# Extended Power baseline proposal

v270

# Goal

Replace Figure 33-18

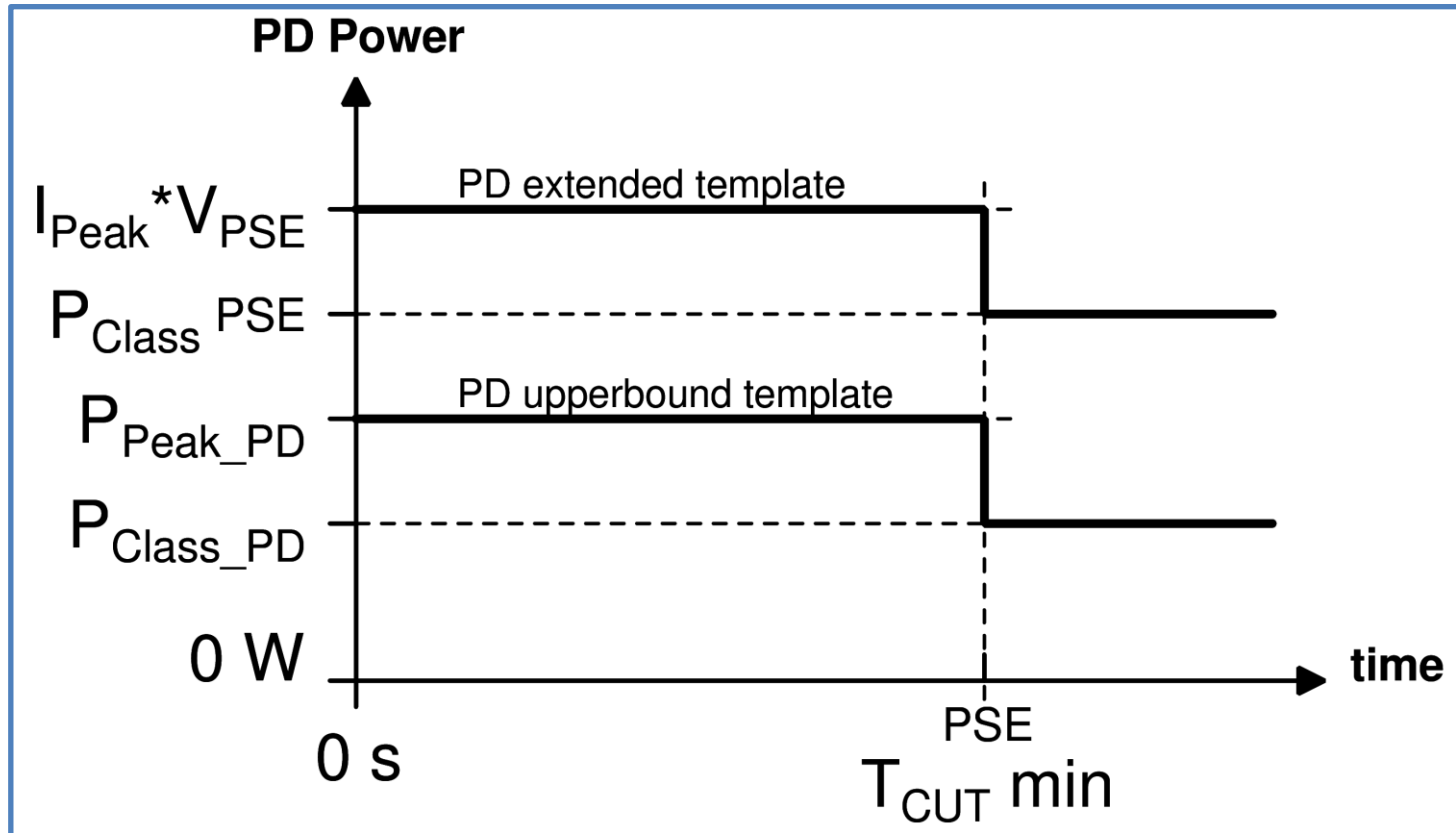
Info: The extended template is based on PSE PI parameters. At  $R_{chan} = R_{ch}$  the extended and upperbound template lines are fully overlapping.

Replace:

Under normal operating conditions when there are no transients applied at the PD PI, the PD shall operate below the PD upperbound template defined in Figure 33–18.

By:

Under normal operating conditions when there are no transients applied at the PD PI, Class 6 or Class 8 PDs, shall operate below the PD extended template defined in Figure 33-18. PDs of all other classes shall operate below the PD upperbound template defined in Figure 33-18.

Clarification: this text & figure do not allow the PD the exceed the upperbound template unconditionally. The condition is that the PSE shall not be caused to source more than  $P_{class}$ . This restriction is handled in section 33.3.7.2.

The PD extended template in Figure 33-18,  $P_{PDET}$ , is described by Equation (33-xx):

$$P_{PDET}(t) = \left\{ \begin{array}{l} I_{Peak} \times V_{PSE} \text{ for } (0 \leq t \leq T_{cut \text{ min}}) \\ P_{Class} \text{ for } (T_{cut \text{ min}} \leq t) \end{array} \right\}^W$$
